In the matter of an application for approvals in relation to the Ryans Road Industrial Development

Supplementary statement of evidence of Andrew Victor Shelley (Fenix)

12 March 2026

- 3 This further statement of evidence is prepared in response to the questions raised by the Expert Panel in Minute 13. In particular, this statement addresses:

Attachment 1:

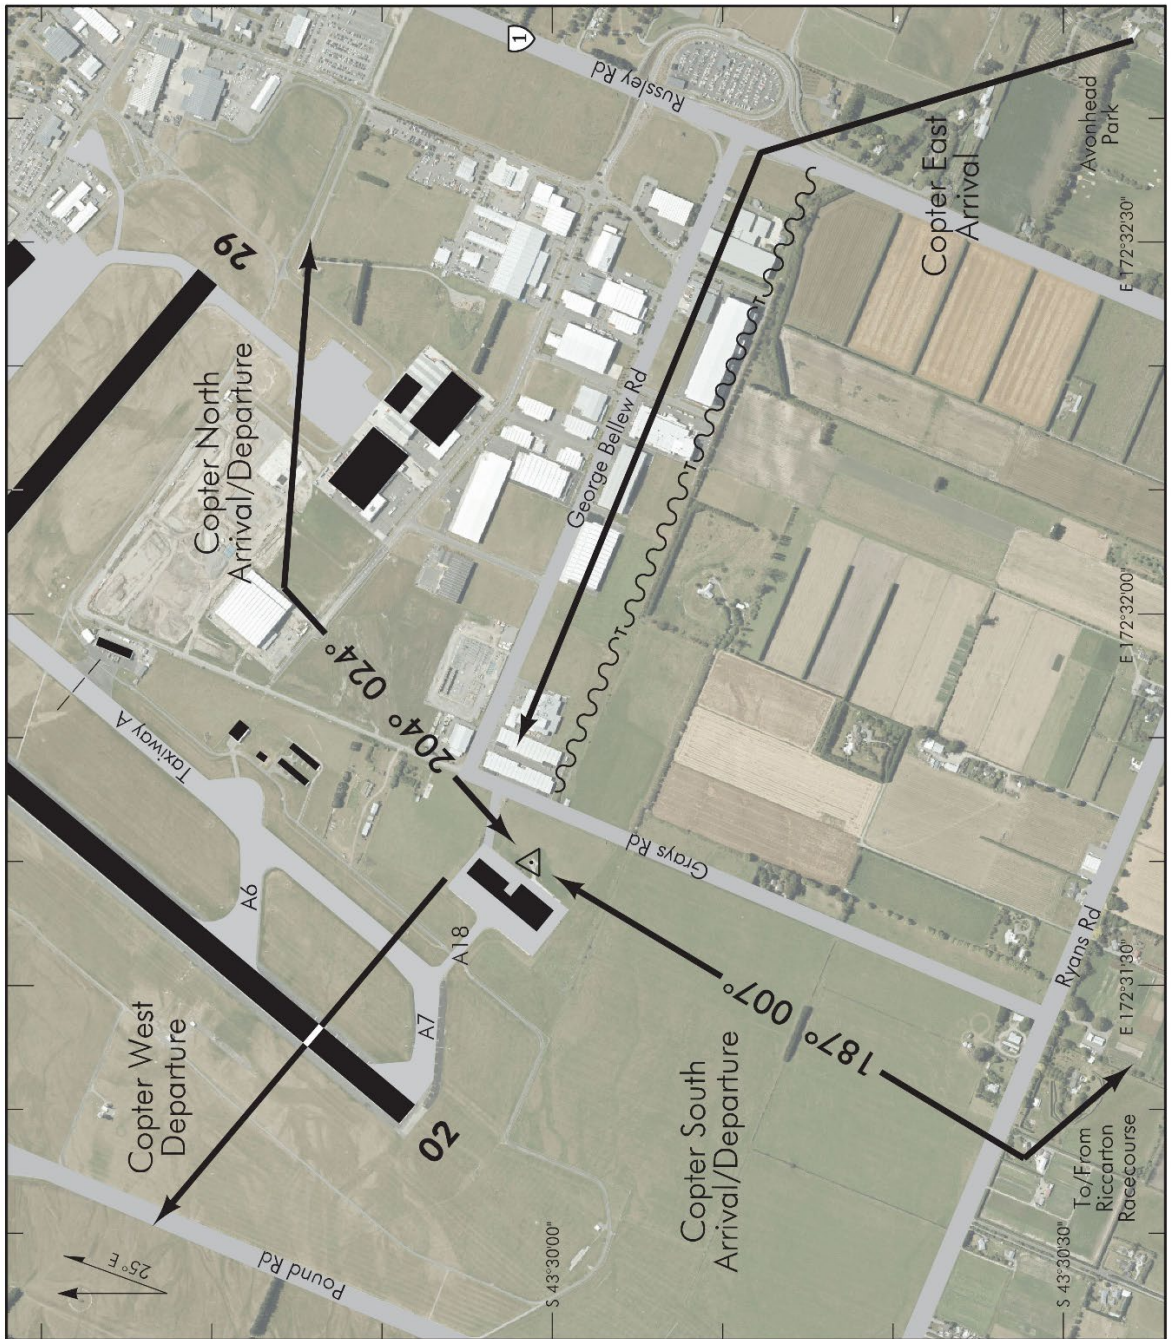
- 5 Included as **Attachments 1 and 2** to this statement are diagrams illustrating the GCH Aeronautical Information Publication (AIP) and arrival/departure paths from the GCH TLOF, as requested by the panel in paragraphs 20-22 of minute 13.
- 6 **Attachment 1** is provided for context and shows the relevant arrival and departure paths for GCH Aviation relative to existing buildings and the subject site. This diagram was created by overlaying the arrival/departure paths from the GCH AIP onto a March 2025 aerial photograph. This diagram shows:
 - (a) The 'Copter West' Departure does not start from the helipad because the GCH complex itself is an obstruction. In this instance a helicopter would need to track north on take-off until it was well clear of the GCH building, then turn west and follow the procedure.

- (b) The 'Copter East' Arrival, as depicted in the AIP, tracks parallel to George Bellew Road, between the road to the north of the arrival track and powerlines to the south. The arrival track is closer to the road than the powerlines and passes over a number of industrial buildings. The AIP does not show the complete track of the helicopter into the helipad, with the indicated track terminating before Grays Rd. In the absence of an indication to the contrary, it is reasonable to assume that helicopters will fly a straight-ahead approach that brings them over the GCH driveway.

- (c) The 'Copter North' arrival/departure tracks to the west of a building on the corner of George Bellew Rd and Grays Rd.
- 7 **Attachment 2** shows the ASI-1204 overlay of the GCH arrival and departure flight paths as provided by CIAL. The project site is shown, with Lots 71, 91, 92, 121 and 122 that are subject to new condition 21D identified in blue. Radial distances from the TLOF area are shown in white and selected key distances from the TLOF area are shown in pink.

Attachment 2:

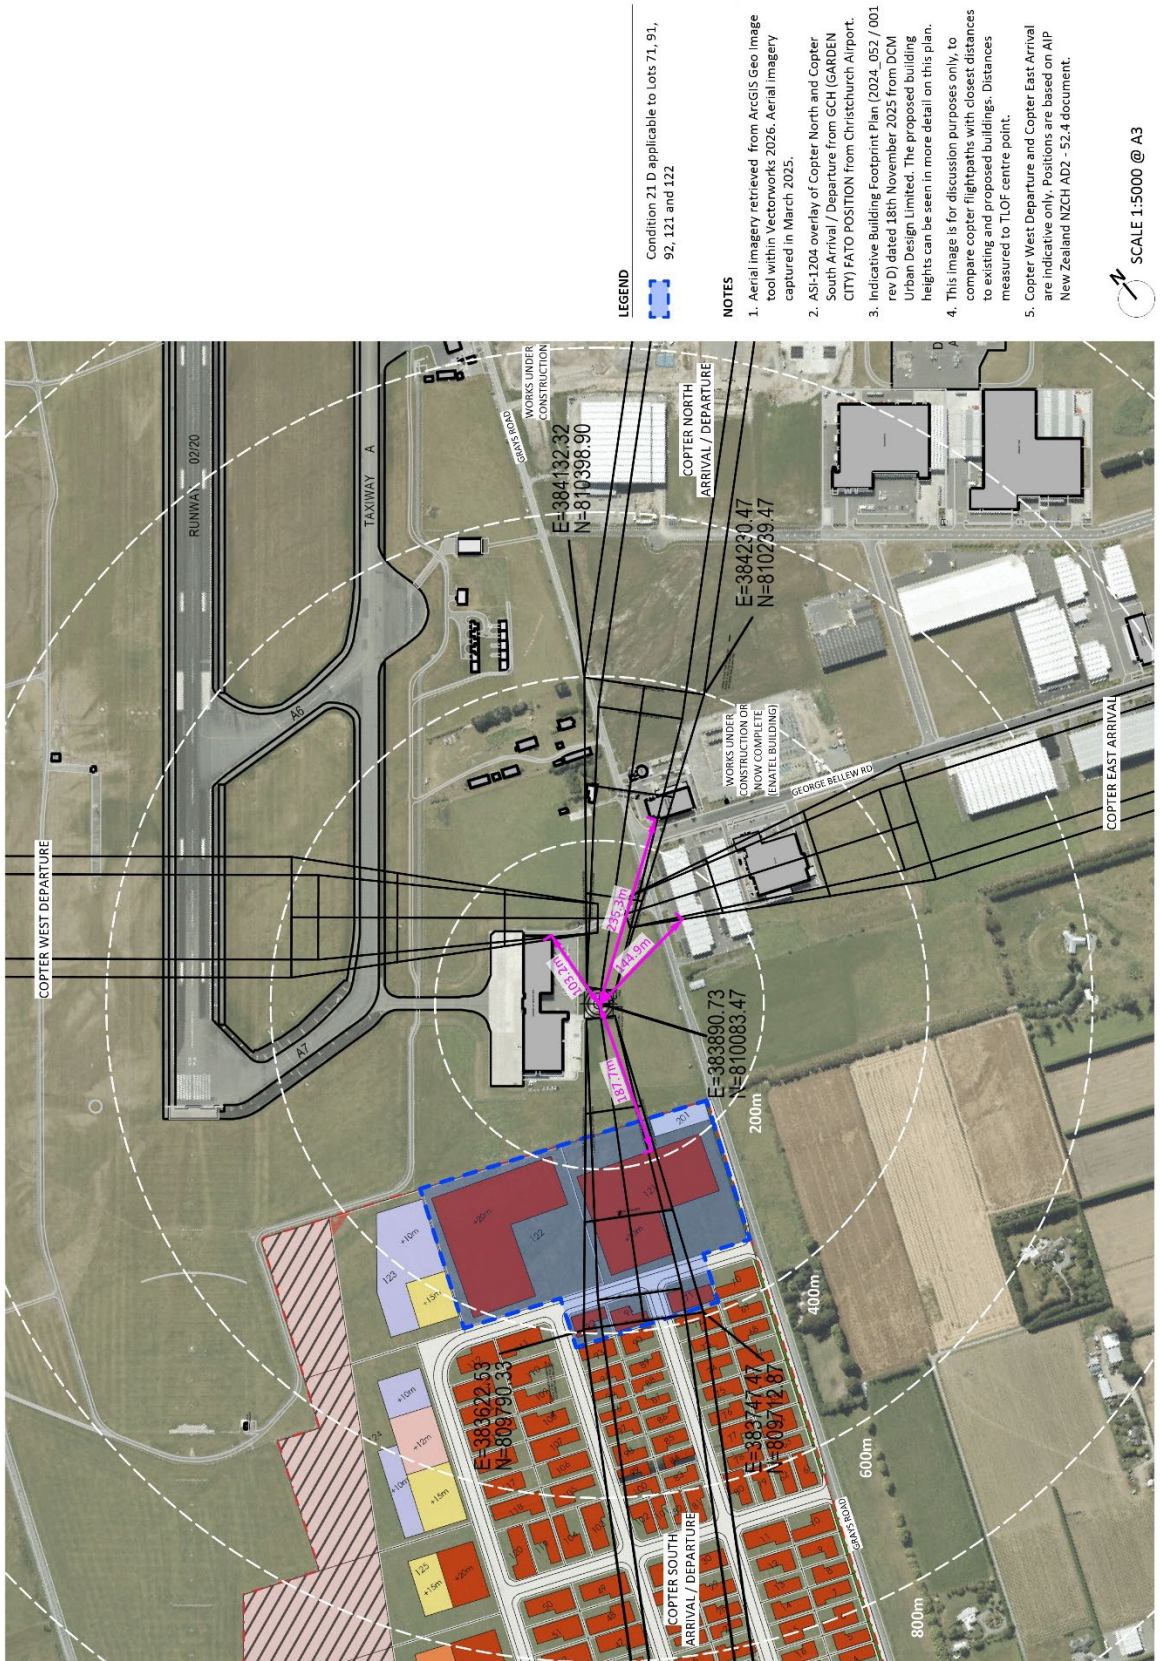
- 8 The arrival and departure flight paths (in black) show:
 - (a) For the 'Copter South' and 'Copter North' arrival and departure paths, the Final Approach and Take-off (FATO) – which provides the starting point for establishing the obstacle limitation surfaces – is co-located with the TLOF.

- (b) For the 'Copter West' departure and 'Copter East' arrival, a notional FATO exists over the driveway into the GCH complex, and the obstacle limitation surfaces begin from this location rather than the TLOF.

- 10 The distances marked on **Attachment 2** show:
 - (a) Within the southern approach pathway to the GCH heliport TLOF, the closest distance between proposed buildings on the subject site and the heliport TLOF are as follows:

- (i) Lots 71, 91 and 92 are between approximately 360m and 400m from the centre of the TLOF; any buildings on these lots will be

subject to a specific aviation risk assessment by way of Condition 21D;

- (ii) Lots 72, 90, and 93 are approximately 400m from the centre of the TLOF, as evident from the radial distances;
 - (iii) At its closest point, the building on Lot 121 is approximately 187.7m from the centre of the TLOF; any buildings on this lot will be subject to a specific aviation risk assessment by way of Condition 21D;

- (iv) At its closest point, the building on Lot 122 is approximately 200m from the centre of the TLOF; any buildings on this lot will be subject to a specific aviation risk assessment by way of Condition 21D;

- (v) Other buildings on the subject site are at least 200m (and generally >400m) beyond the centre of the TLOF, as evident from the radial distances.

- (b) Within the northern approach pathway to the GCH heliport TLOF, the closest distance between existing buildings on other sites and the heliport TLOF are as follows:

- (i) 103.2m to the southeast corner of the GCH Aviation building for the 'Copter West Departure' (noting other parts of this same building are considerably closer);

- (ii) 144.9m to the nearest point where the OLS for the 'Copter East Arrival' passes over the long warehouse building to the southeast (a distribution centre for a business called 'Online Distribution');

- (iii) 235.3m to the nearest part of the building to the east-southeast (a distribution centre for a business called 'Geofabrics New Zealand');
 - (iv) A number of other buildings are between 200m and 800m of the TLOF (and beyond), as evident from the radial distances.

**Attachment 3: Capture plan RC-PG125, GARDEN CITY
HELICOPTERS PROTECTION SURFACES**

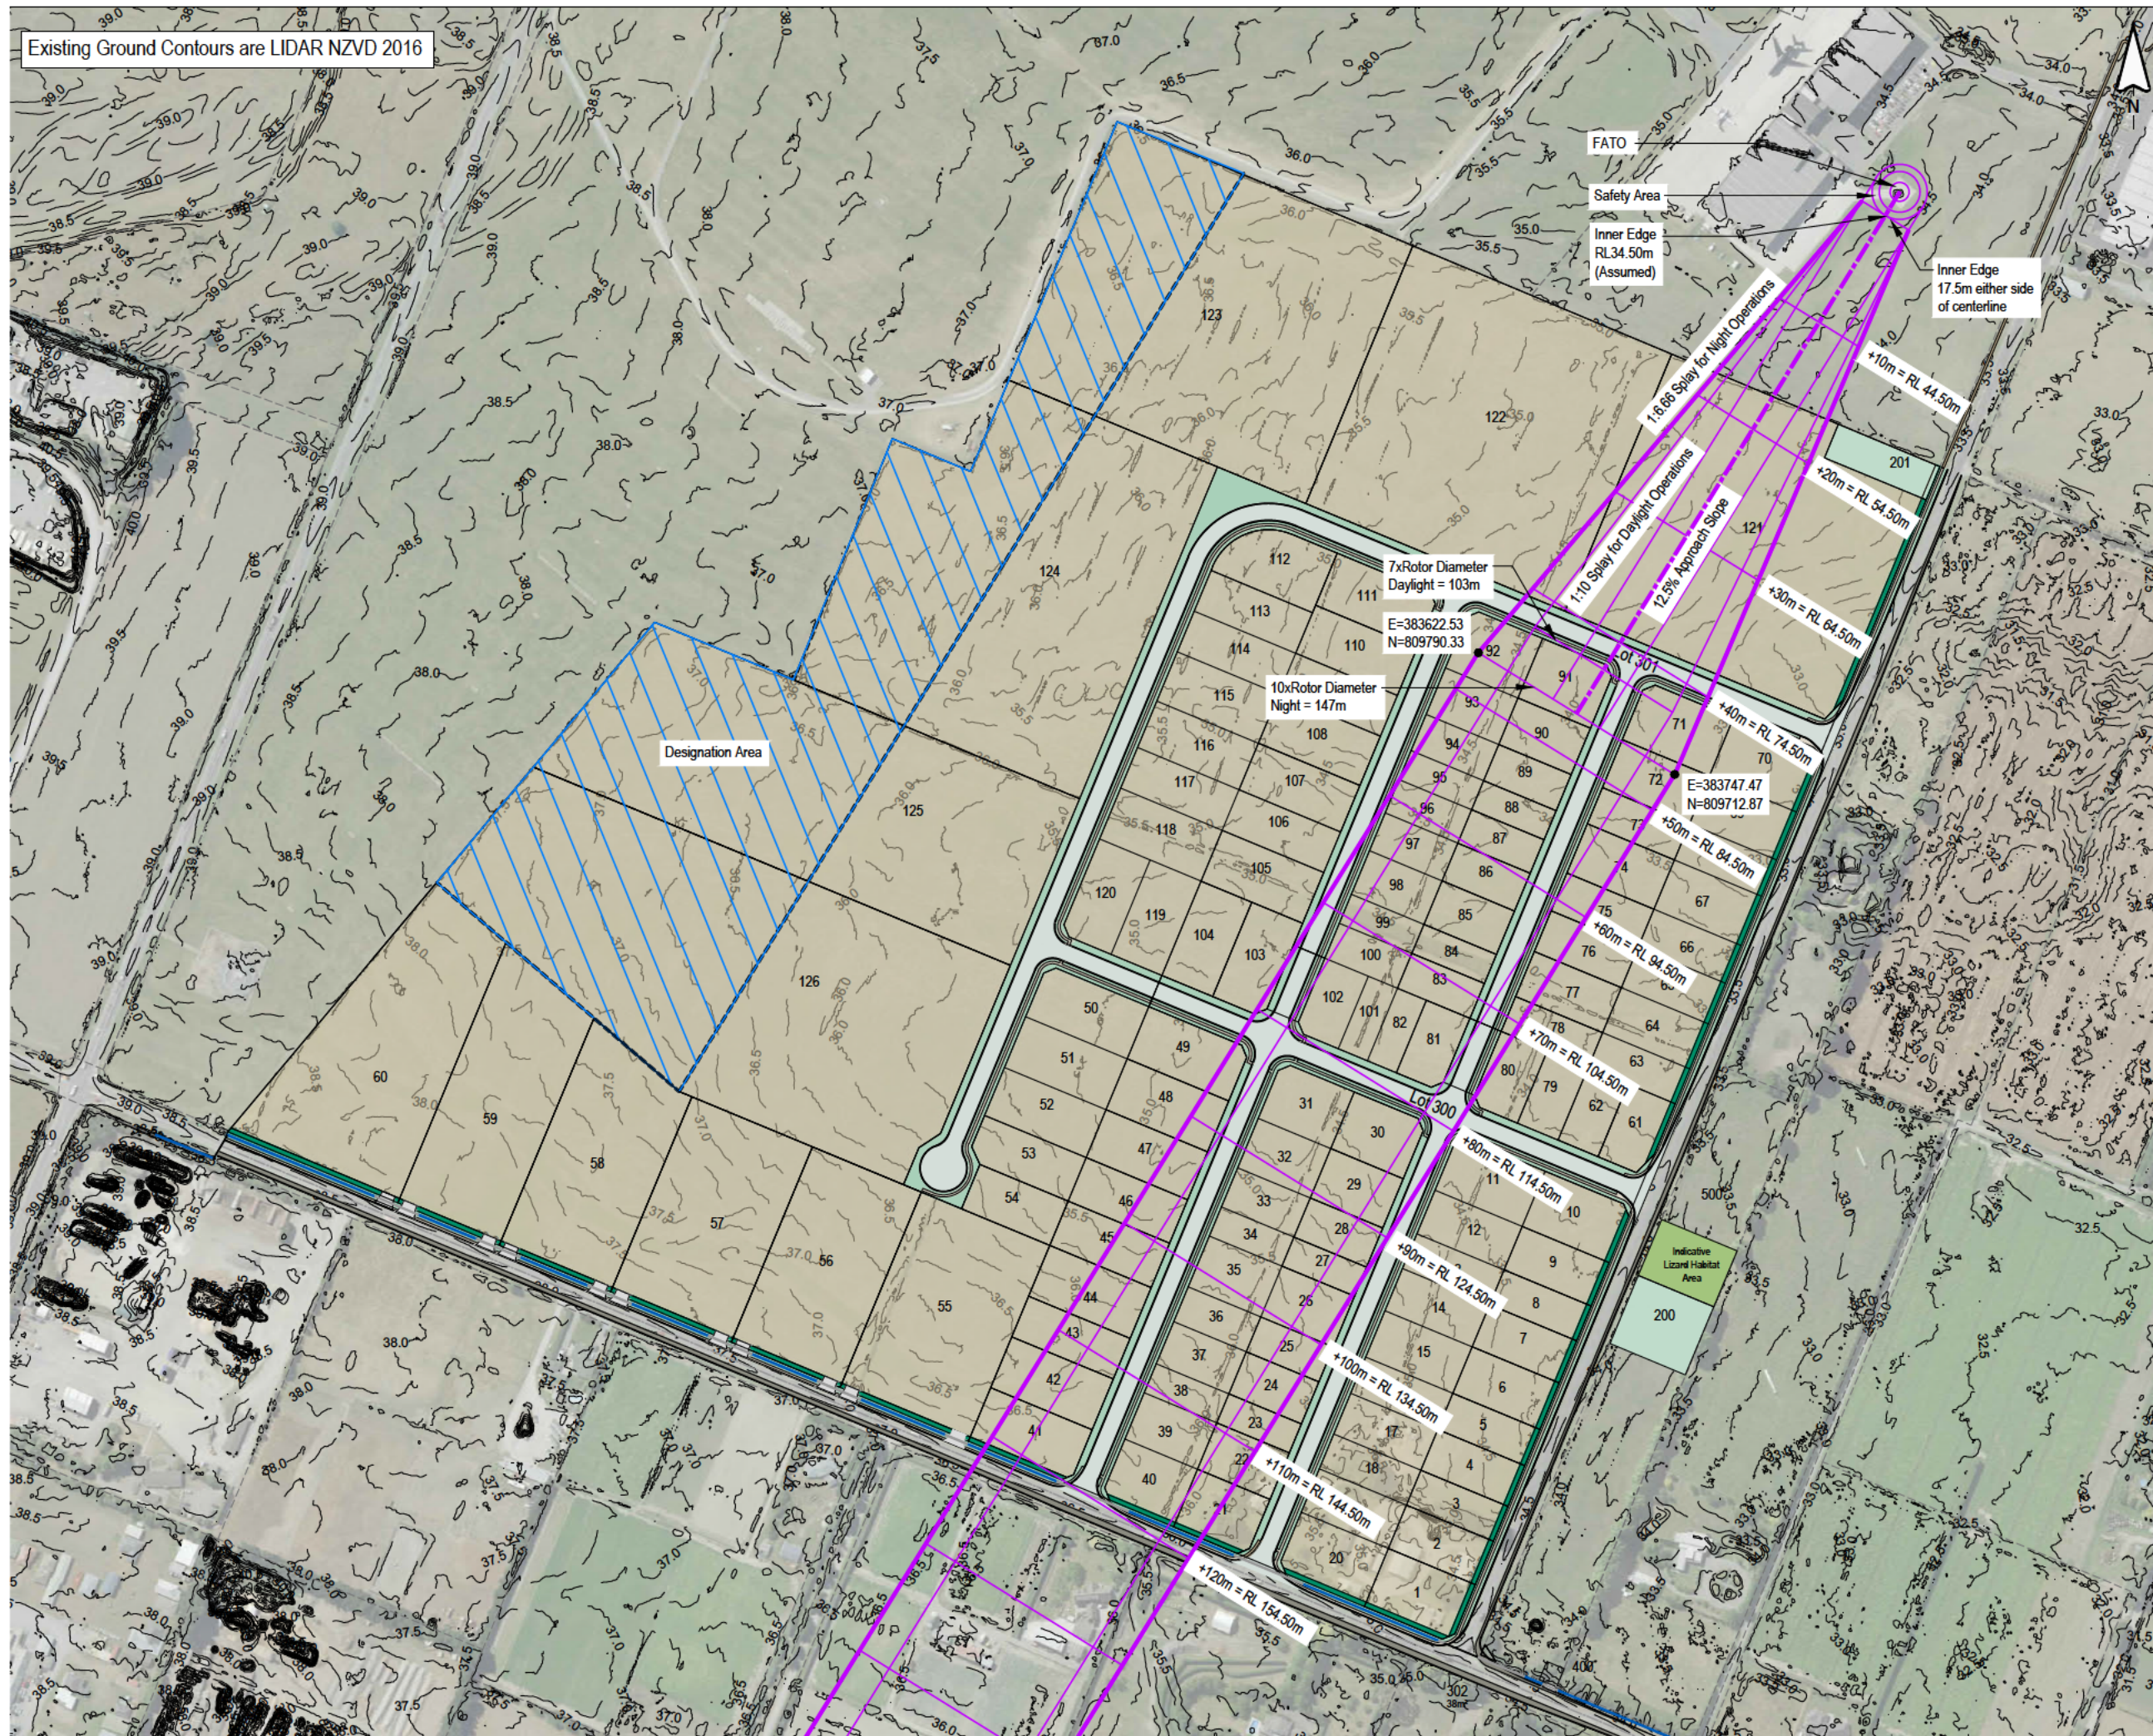
- 16 The relevant requirements of AC139-8 are those set out on page 13, section 4.1.1-4.1.4 of AC139-8.¹ An assessment of these requirements is set out in the table below, with reference to the Capture plan RC-PG125 which accurately depicts the obstacle limitation surface for the GCH 'Copter South' arrival/departure if the helicopter does not cross Grays Road. For ease of reference, a copy of Capture plan RC-PG125 is included as **Attachment 3**.
- 17 The assessment in the table confirms that the proposal (as governed by conditions of consent) will meet the requirements of advisory circular AC139-8.

4.1.1 <i>The heliport should have sufficient approach and take-off climb surfaces to ensure that a helicopter can conduct a landing or take off in the existing wind conditions.</i>	✓ The proposal provides appropriate approach and take-off climb surfaces to the south of the GCH heliport, as detailed below in response to AC139-8 section 4.1.2. ✓ In addition, condition 21D provides for more detailed assessment of development of that part of the site immediately south of the GCH heliport (specifically Lots 71, 91, 92, 121, 122).

4.1.2 <i>The approach and take-off climb surface should:</i>	
<i>(a) extend from the edge of the safety area</i>	✓ The approach and climb surface (purple lines) extends from the edge of the safety area around the helipad.
<i>(b) have an inner edge that is at least equal in length to the width or diameter of the FATO plus the safety area to either side</i>	✓ The 'inner edge' of the surface is at least as wide as the width or diameter of the FATO plus the safety area to either side.
<i>(c) for day operations, have sides splaying out at 1:10 until the surface is 7 rotor diameters wide, after which they may become parallel</i>	✓ For day operations, the surface has sides splaying out at 1:10 until the surface is 7 rotor diameters wide, after which they become parallel. The day

surface is depicted by a thin purple line inside the thicker purple lines that depicts the surface required for night.
<i>(d) for night operations, have sides splaying out at 1:6.66 until the surface is 10 rotor diameters wide, after which they may become parallel</i>	✓ For night operations, the surface has sides splaying out at 1:6.66 until the surface is 10 rotor diameters wide, after which they become parallel. The night surface is depicted by the thick purple lines.
<i>(e) have an obstacle free gradient not steeper than 1:8</i>	✓ The surface has a slope of 12.5% (which is 1:8). This is depicted by the dash-dot centre line of the splayed part of the surface, and also by the labels +10m, +20m, +30m, etc annotated at the right hand side of the depicted surface.
<i>(f) terminate at an elevation of 500 feet above the inner edge which equates to 1220 m horizontally from the inner edge and</i>	✓ The surface should terminate at 500 feet above the inner edge. 500 feet is 152.4m, which takes the surface beyond the southern extent of the Capture plan.

<i>(g) where a turned flight path is required — (i) not turn below 100 feet above the inner edge elevation (ii) not turn through more than 120° (iii) have a turning radius, on centre line, of not less than 270 m.</i>	✓ With the current 'Copter South' arrival/departure this is not relevant. ✓ If a turned flight path was required as a result of a further assessment per condition 21D then this condition would continue to be met.
Operational safety	
<i>4.1.3 A major safety consideration of a heliport is the availability of suitable approach and take-off climb surfaces. Heliports should have approach and take-off paths such that, if the helicopter is not a performance Class 1 helicopter, an autorotative landing can be conducted without any undue risk to any person on the ground.</i>	✓ This has been assessed in detail in section 7 of the Navigatus assessment dated 28/11/2025 and I agree with that assessment and its conclusions. ✓ In addition, condition 21D now proposed provides for more detailed assessment of development of that part of the site immediately south of the GCH heliport, in a manner consistent with the 'controlled area' described in section 7.5 of the Navigatus assessment.

<i>4.1.4 The approach and take-off flight paths should be over terrain which affords emergency landing areas in relation to the</i>	✓ This has been assessed in detail in section 7 of the Navigatus assessment
